From: Amanda Scholes on behalf of Planning.Responses
Sent: 15 October 2019 08:51
To: Planning Scanning
Subject: FW: Planning Consultation on A/132/19/DOC
Attachments: Soakaway Test Extract.pdf; P19.117 - Winter GW monitoring 01.10.19.pdf; Soil Summary.pdf

APPLICATION NO: A/132/19/DOC

Site Address: Merry England Nursery Dappers Lane Angmering BN16 4EN

Description of Works: Approval of details reserved by condition imposed under ref
A/142/16/OUT relating to Condition Nos 4 - surface water drainage, 6
- flows to watercourses, 7 - SuDs system, maintenance of any

Winter Groundwater Monitoring Record

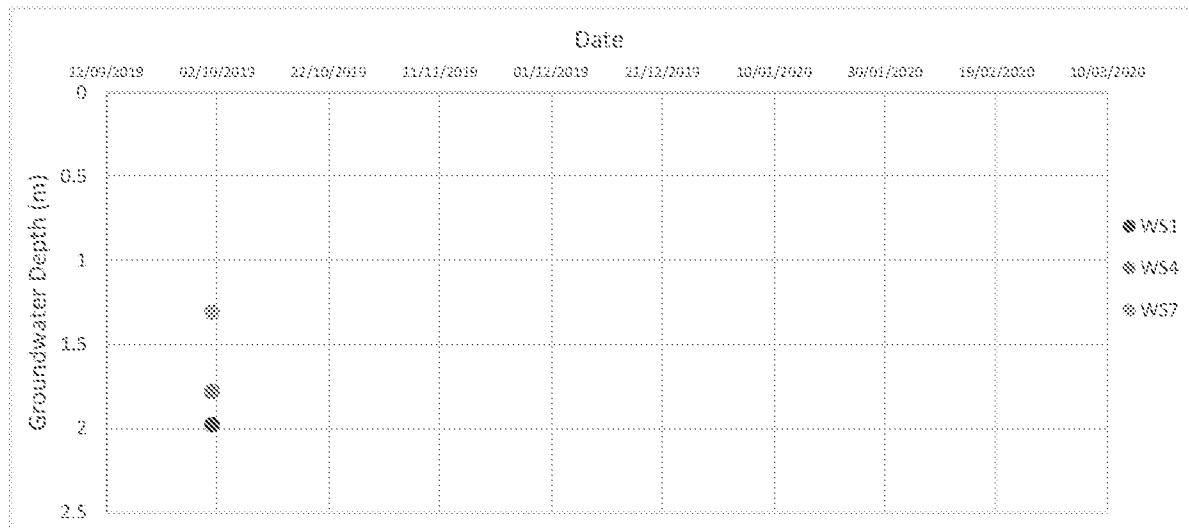
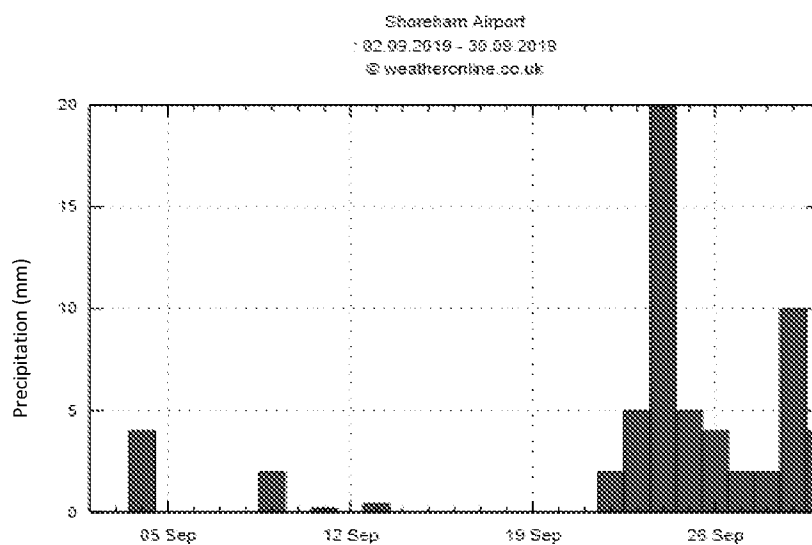
No winter groundwater monitoring or infiltration testing results have been submitted. It is not appropriate to review the surface water drainage strategy without this information.

Please re-consult us once winter ground water monitoring and winter infiltration testing has been completed and results are provided. Please note, that this information may not be available until April after the winter monitoring period has ended.

I attach an extract from the geotechnical report indicating the soakaway test results and the first recordings of the ground water monitoring which began at the start of the month.

The geotechnical Engineer working on this scheme also worked on the adjacent site and noted water levels rose to around 0.5m below ground level during peak GW levels. It is therefore anticipated that the groundwater will rise considerably higher than what is shown.
